DEVELOPMENT
APPLICATION

DRAWING REGISTER

OUR LADY OF THE ROSARY
CATHOLIC SCHOOL
The Entrance

PROJECT NAME :
**OUR LADY OF THE ROSARY
CATHOLIC SCHOOL**

PROPOSED OVERALL LEVEL 1 FLOOR PLAN

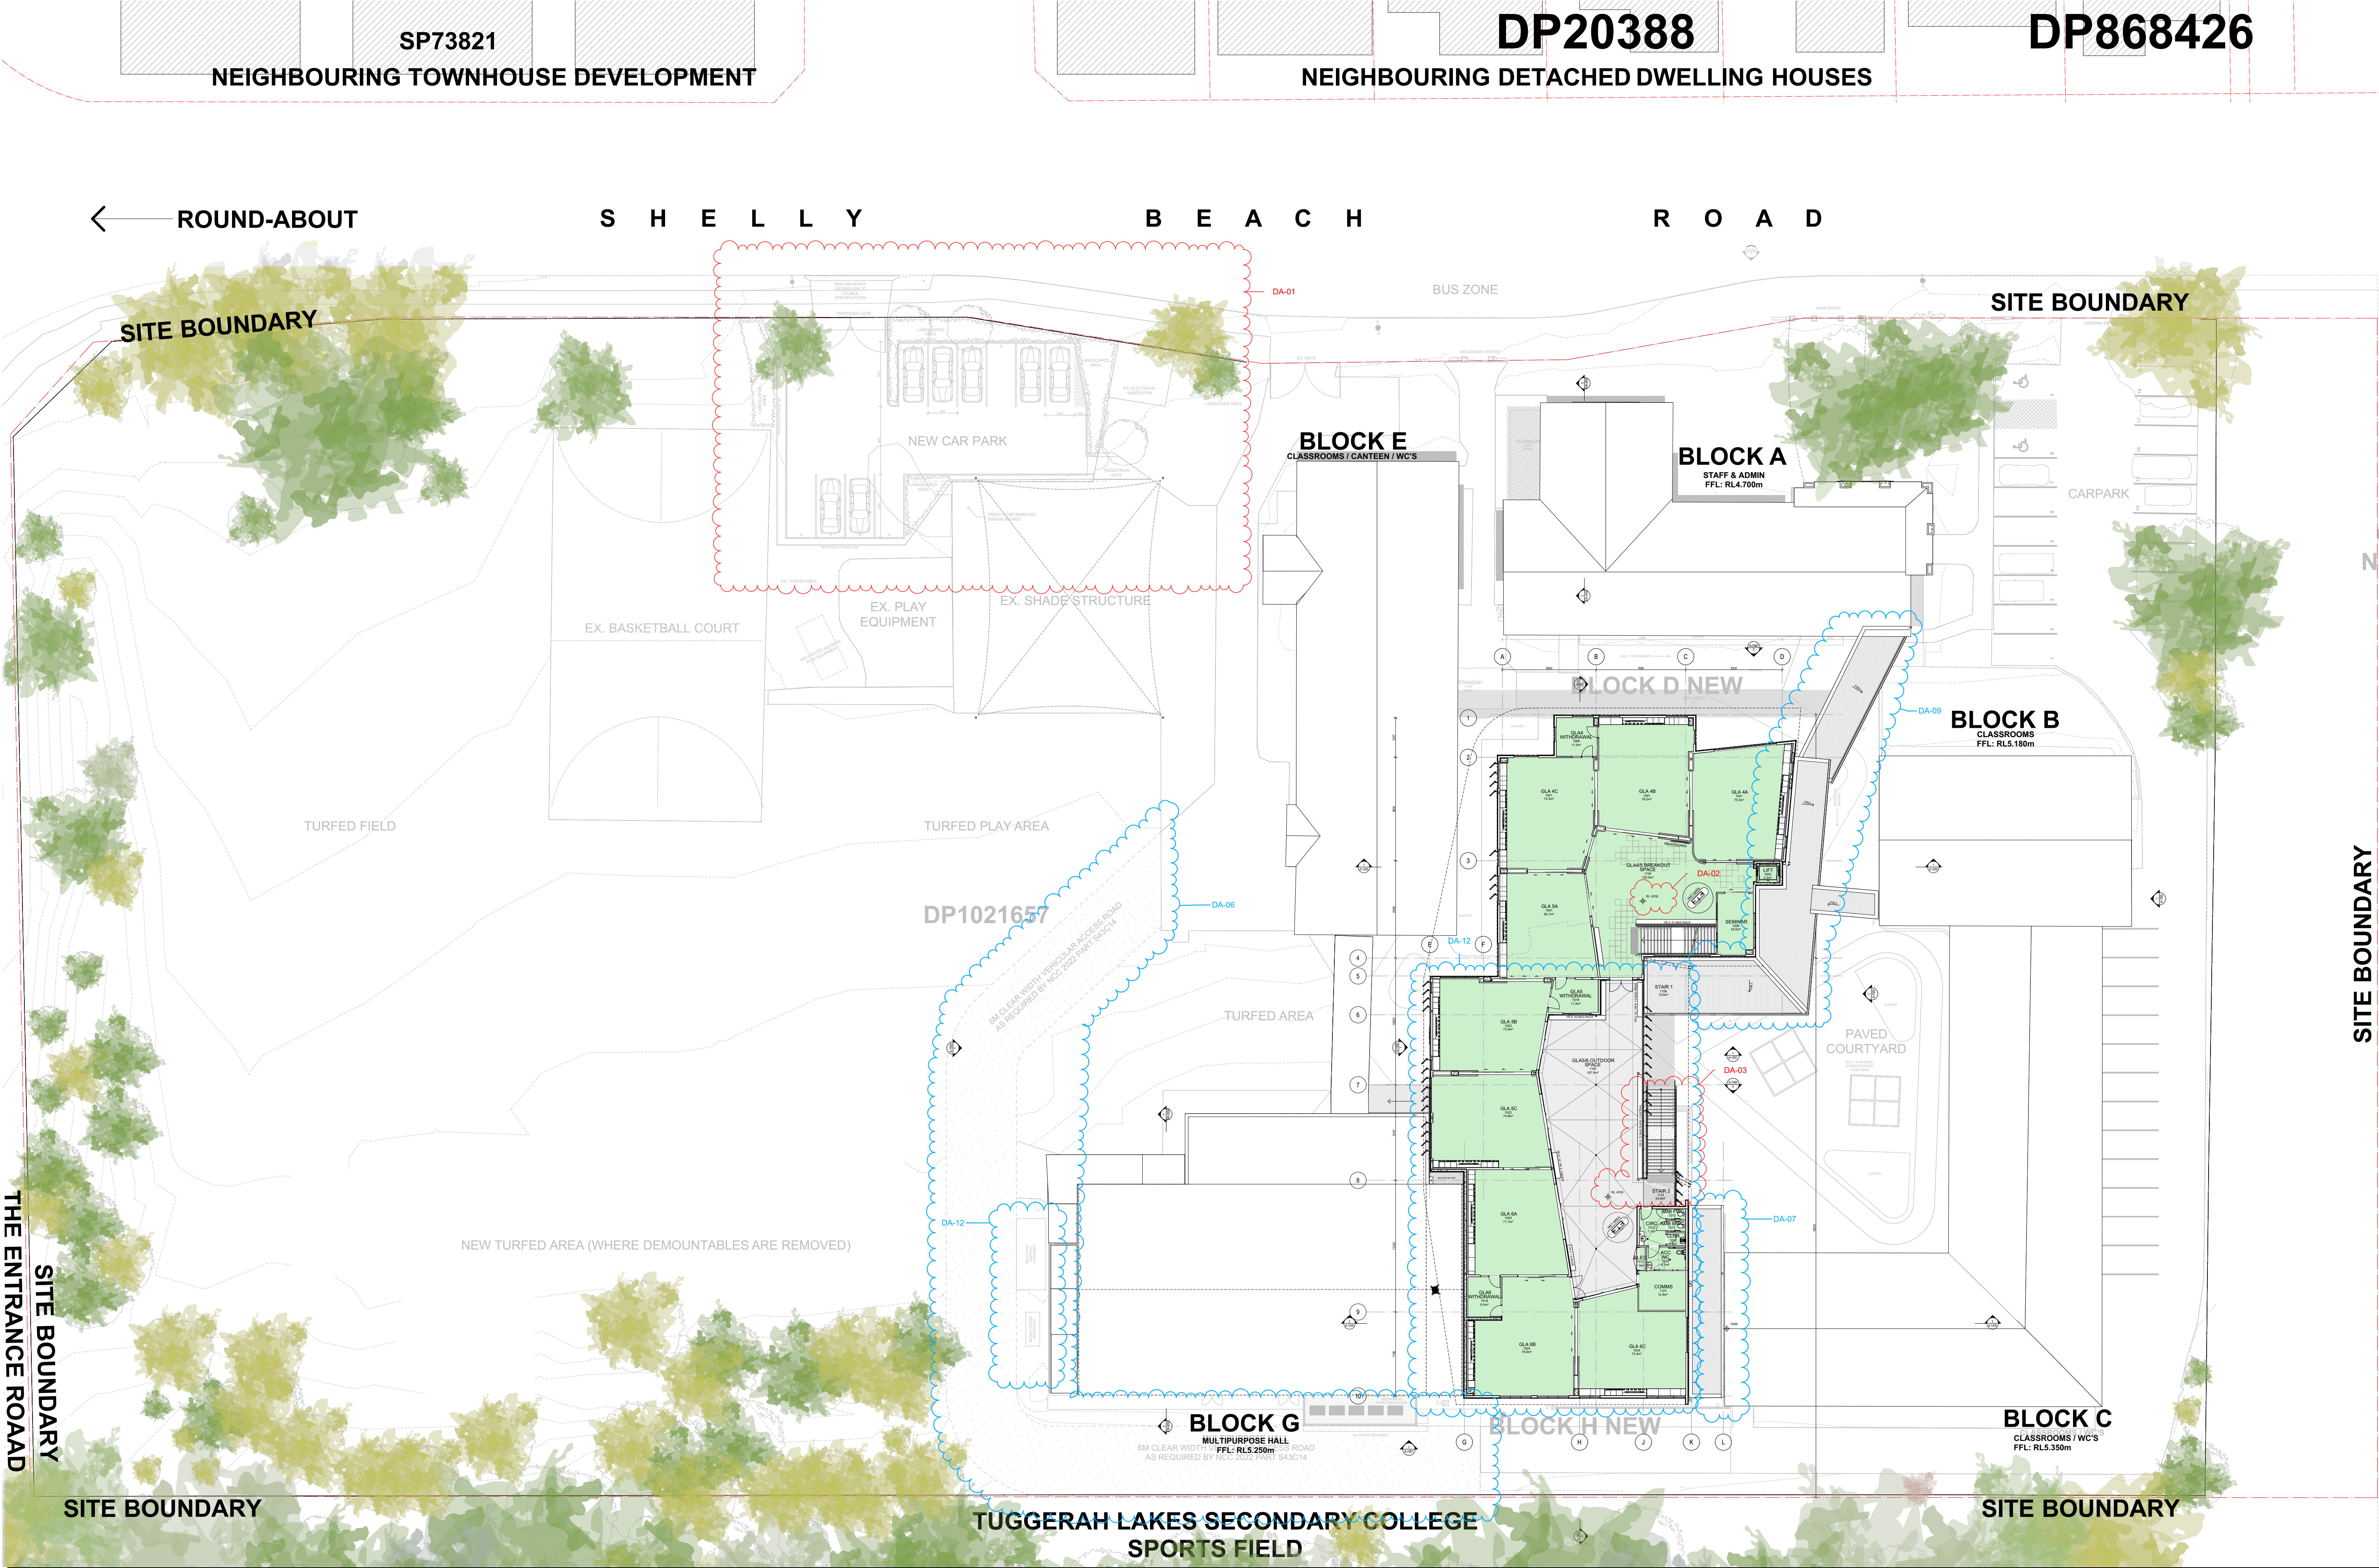
DA-12	GLA'S RECONFIGURED AROUND EXTERNALISED SHARED SPACE
DA-09	ENTRY CANOPY REDUCED IN SIZE
DA-07	BLOCK H WALL MOVED AWAY FROM BLOCK C
DA-08	GLA2 SHARED SPACE EXTERNALISED
DA-03	STAIRS AND RAMP ADJUSTED TO SUIT NEW FFL
DA-02	FFL RAISED TO SUIT FLOOD LEVEL
DA-01	REVISED CARPARK LAYOUT

DRAWING TITLE: GA FLOOR PLANS	DRAWING SCALE: 1:100, 1:50 @ A1	REVISION NO. 08
PROJECT NAME: OUR LADY OF THE ROSARY CATHOLIC SCHOOL	PROJECT NUMBER: 1382	STAGE: DA DRAWING NO.: A-1103

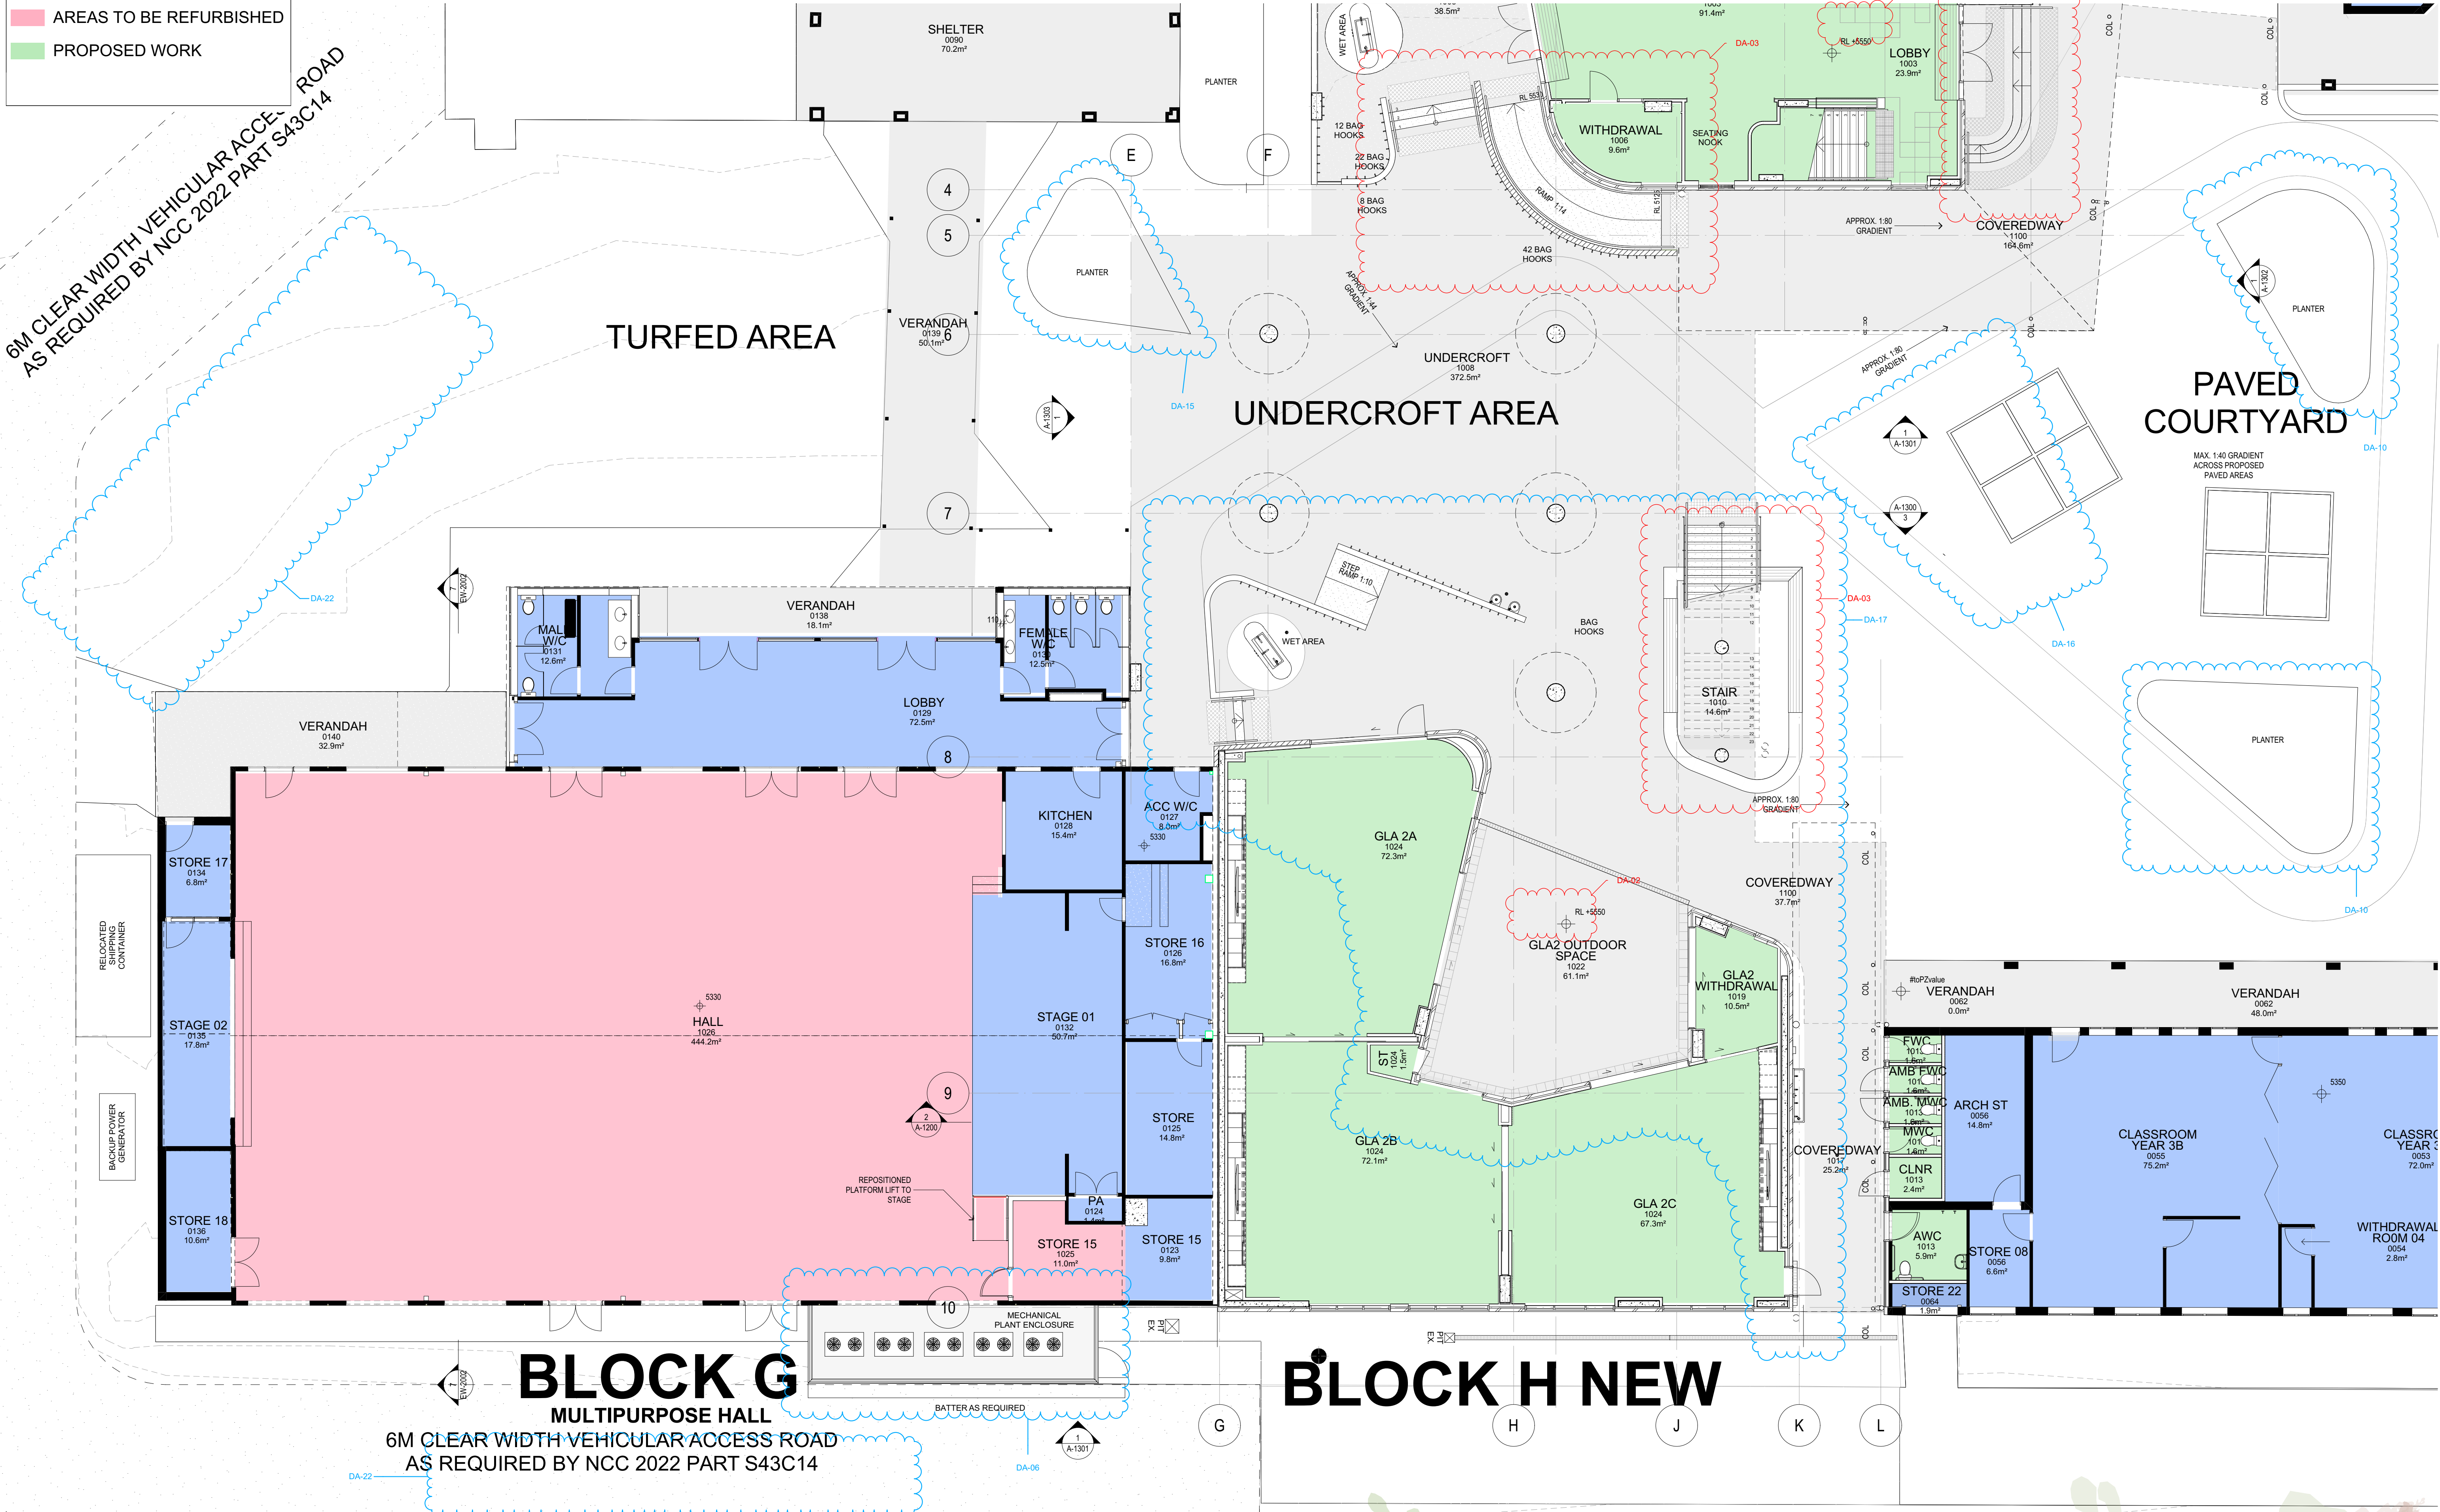
REVISION	CHANGE REGISTER
DA-22	VEHICULAR ACCESS PATH ADDED AS REQUIRED BY NCC 2022
DA-17	PLANT ROOM MOVED FURTHER WEST
DA-16	GARDEN BED DELETED
DA-15	GARDEN BED ADDED
DA-10	RAISED PLANTER BEDS LOWERED / REDUCED
DA-06	GLA2 SHARED SPACE EXTERNALISED
DA-03	STAIRS AND RAMP ADJUSTED TO SUIT NEW FFL
DA-02	FFL RAISED TO SUIT FLOOD LEVEL

DRAWING TITLE:
GA FLOOR PLANS
PROPOSED BLOCK H GROUND FLOOR PLAN 1:100, 1:50 @ A1
PROJECT NAME:
OUR LADY OF THE ROSARY CATHOLIC SCHOOL
DRAWING SCALE:
PROJECT NUMBER:
1382

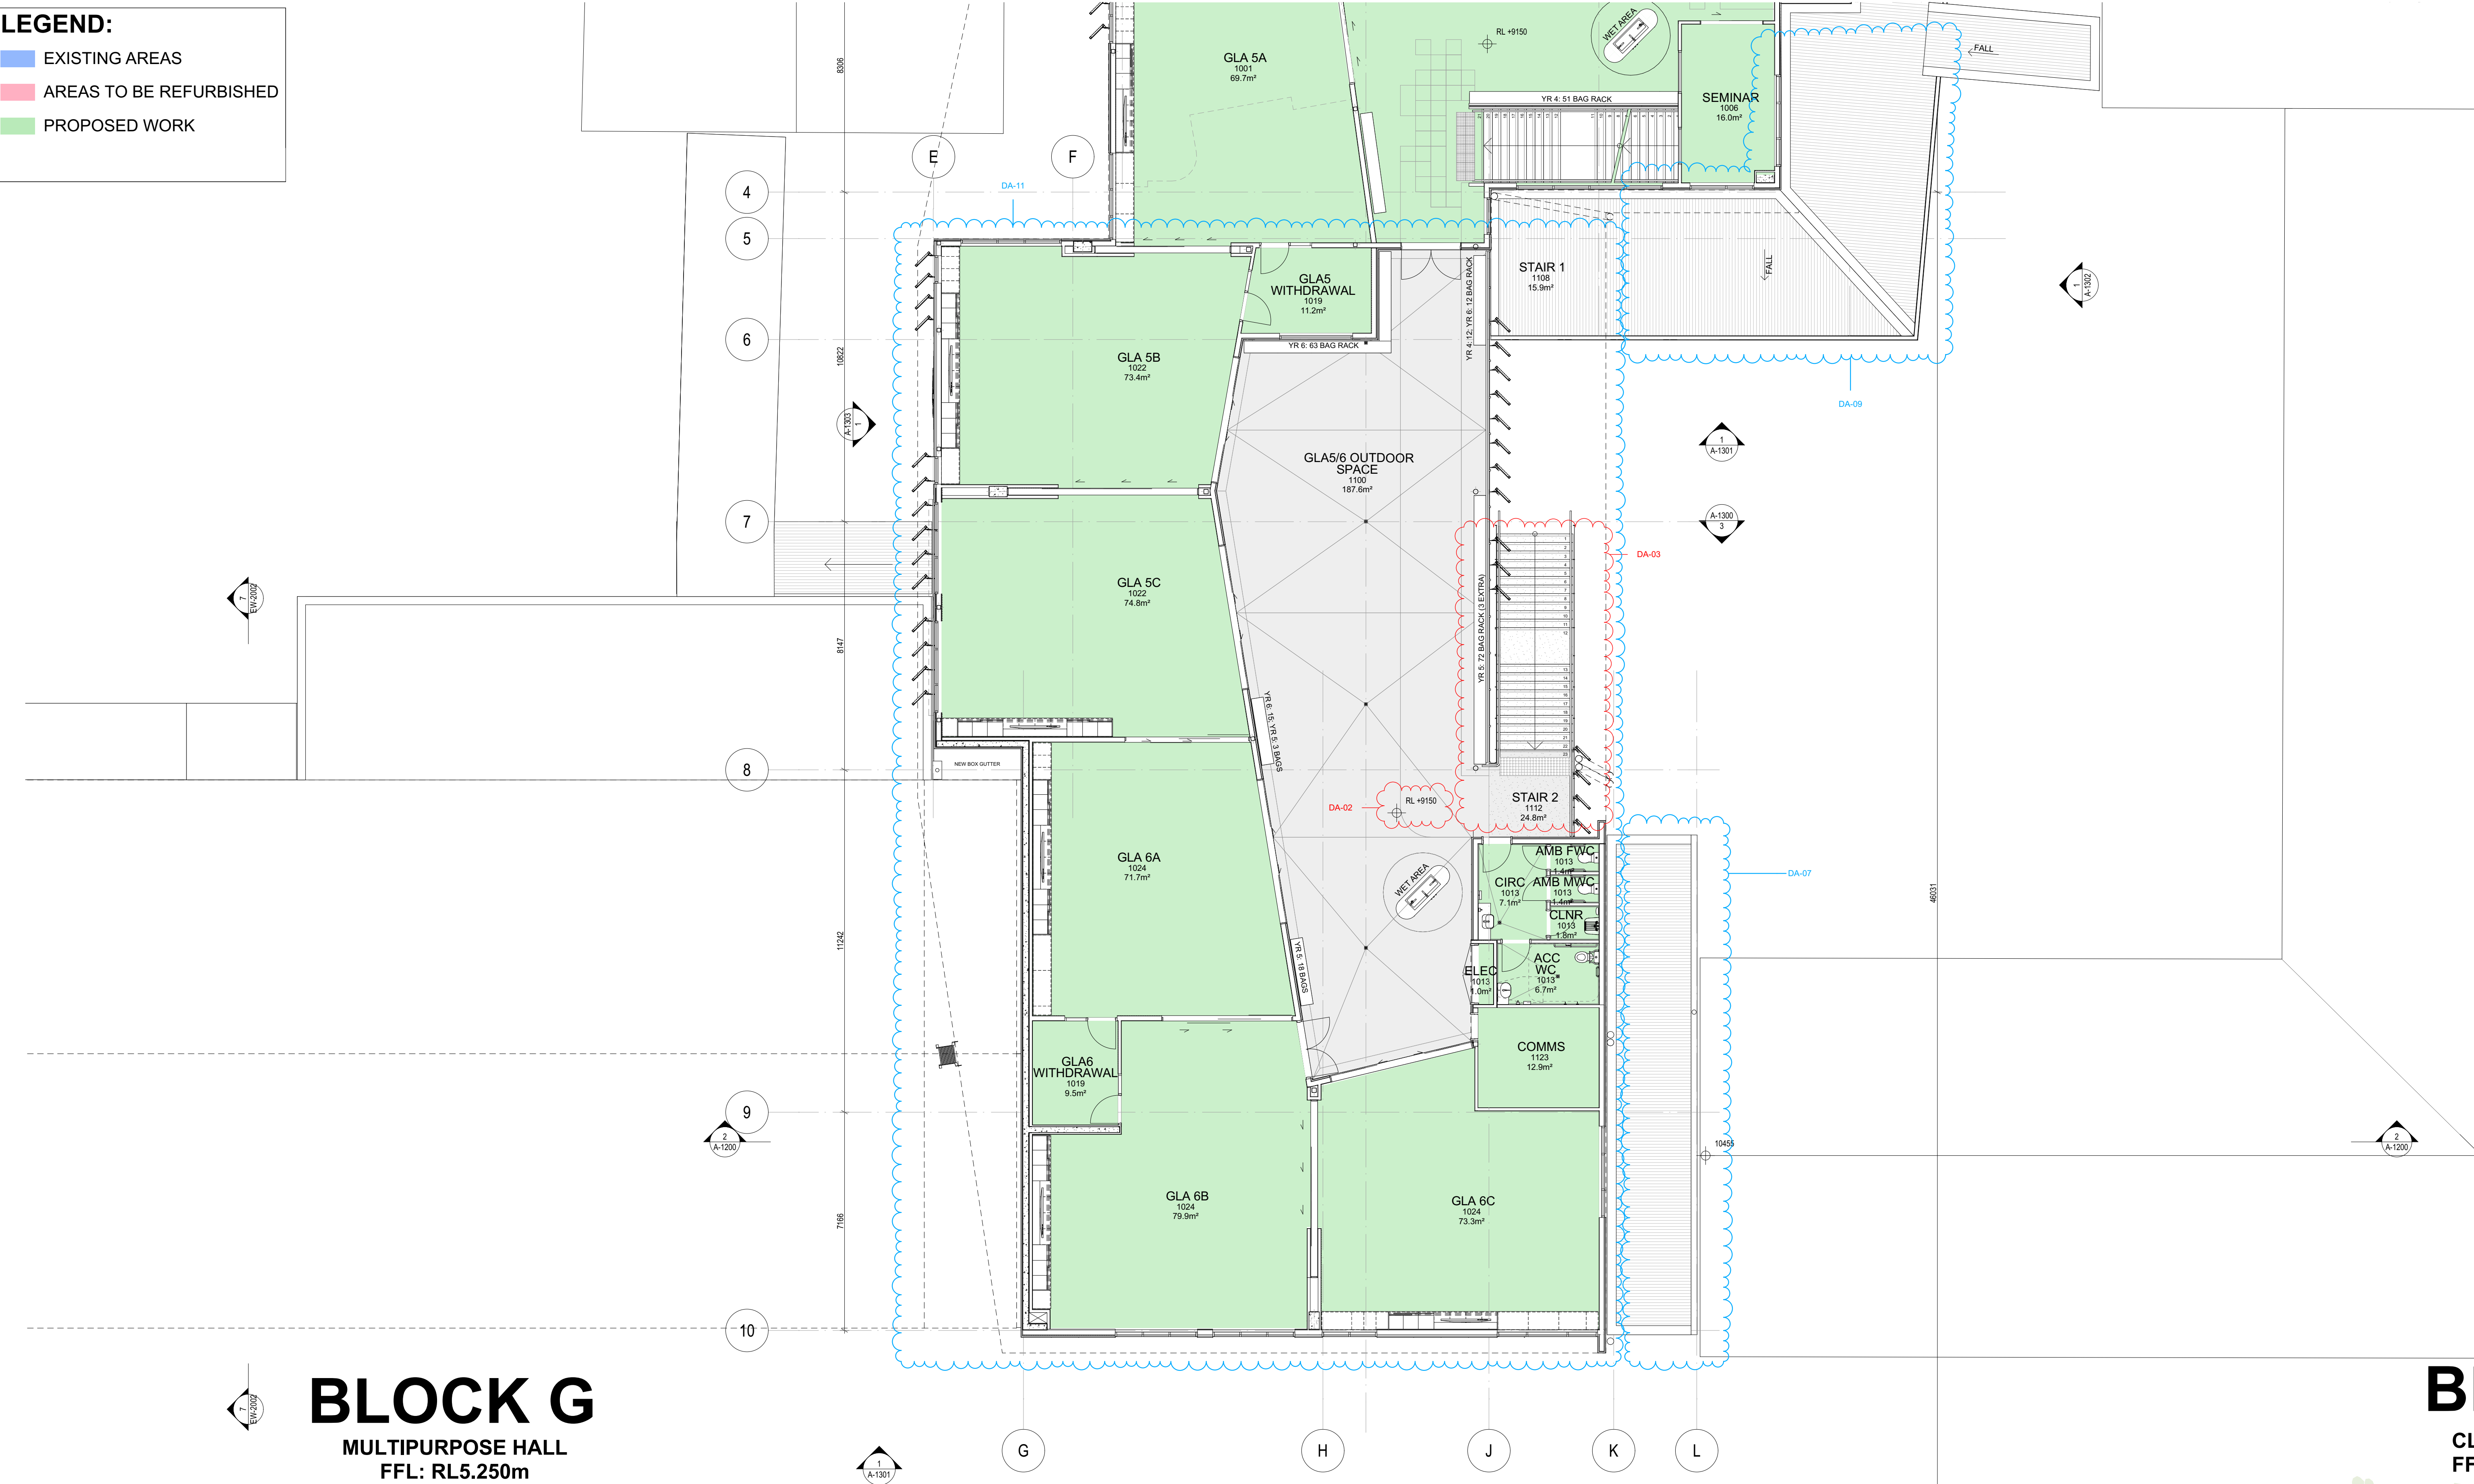
NO.	REVISION	DATE	DESCRIPTION
1	DA-11	11/05/2023	MAINTENANCE STORE DELETED
2	DA-09	11/05/2023	ENTRY CANOPY REDUCED IN SIZE
3	DA-07	11/05/2023	BLOCK H WALL MOVED AWAY FROM BLOCK C
4	DA-03	11/05/2023	STAIRS AND RAMP ADJUSTED TO SUIT NEW FFL
5	DA-02	11/05/2023	FFL RAISED TO SUIT FLOOD LEVEL
